No. 0-5

SEPT. 1965

TO: ALL ROOTES GROUP DEALERS
MODEL: SUNBEAM IMP
SUBJECT:
SUBJECT: BATTERY CORROSION OF INNER WING PANEL.

FIG. 1

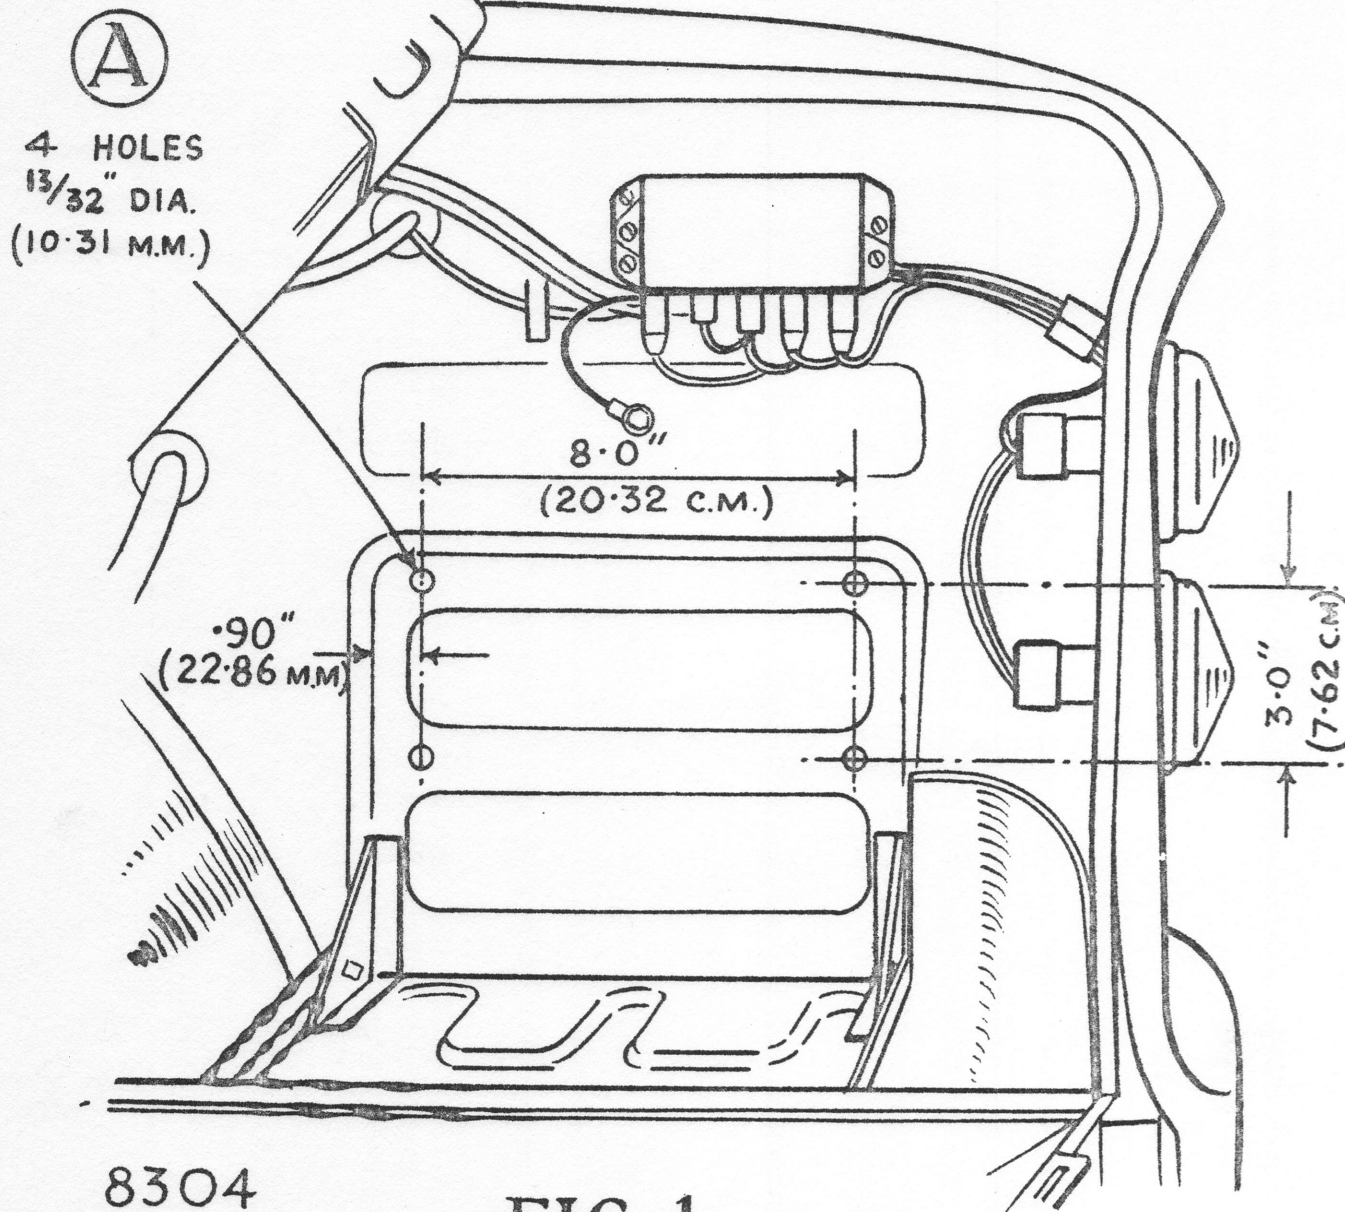
See Illustration No. 8304 & 8305, attached

FIG. 2

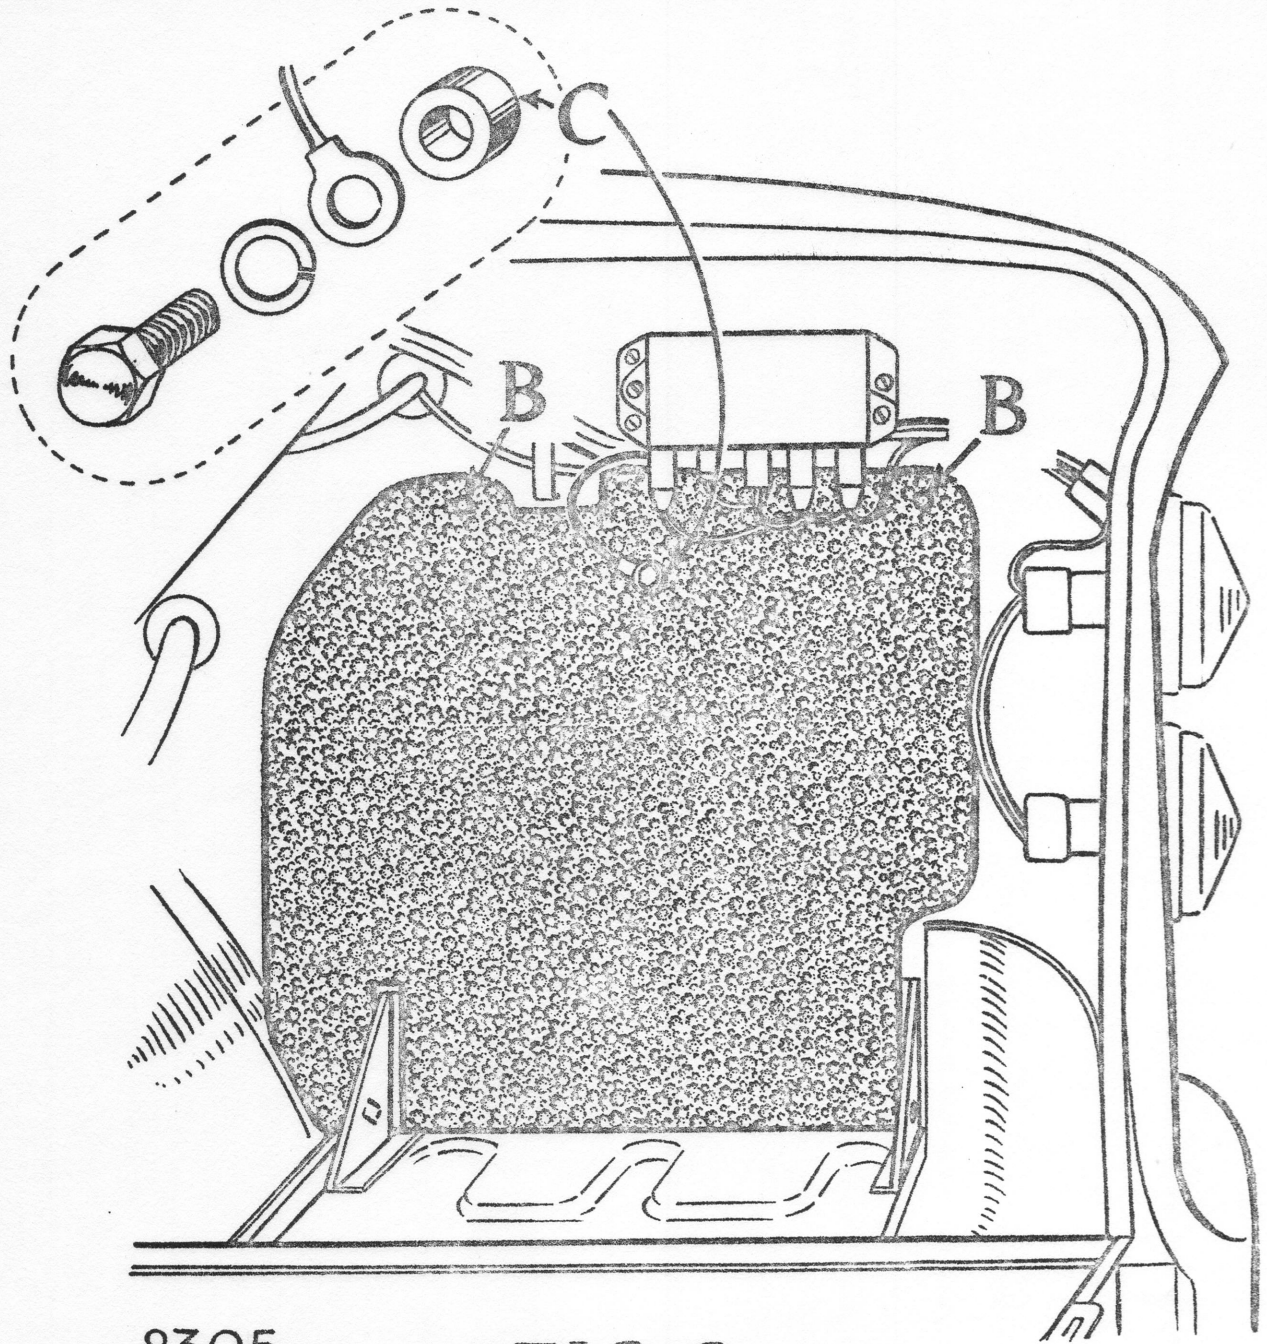
Where perforation of the inner panel has occurred, it is recommended that the inexpensive Repair Kit, Part No. 7096094 (containing fibre glass panel, distance piece and bolt) is fitted as per the following instructions:-

5. Offer up the fibre glass panel and locate it temporarily in position, using the distance piece and new 1/4" UNF bolt supplied. Drill 2- (No.36 drill) .106" (2.7 mm) diameter holes as shown at 'B' in Fig.2. and secure fibre glass, using 2- drive screws, Part No. 9772086 with a plain washer Part No.9067092 under the heads.
